Water Resources Department

FINAL ORDER

REQUEST FOR WRITTEN APPROVAL TO USE CONSTRUCTION METHODS NOT INCLUDED IN OREGON ADMINISTRATIVE RULES 690-200 THROUGH 690-240

(2) Start Card Number(s)(for work to be done): 1010016

- (7) Diagram showing the pertinent features of the proposed well design and construction:
(attach additional pages if needed)

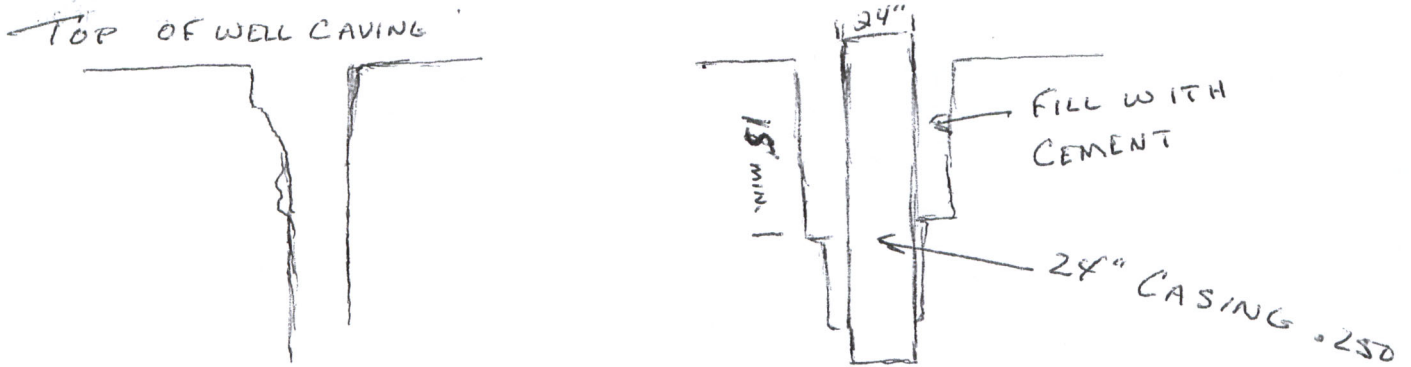
(5) The unusual site conditions which necessitate this request: UNSTABLE GROUND

NEAR SURFACE (VERY SANDY WITH HIGH WATER TABLE)

INSTALL 18-20" X 250 X 24" CASING. CEMENT THE UNSTABLE

AREA TO DEPTH OF 15-18'

The Special Standard request you submitted for owner: Edward Stuedli, Start Card number 1010016, is hereby approved for the following: You may repair the unstable ground surrounding this well as described on your Special Standards Request form. The repair shall extend to a minimum depth of 15 feet bgs. All other standards must be adhered to. Your Special Standard request form is enclosed.
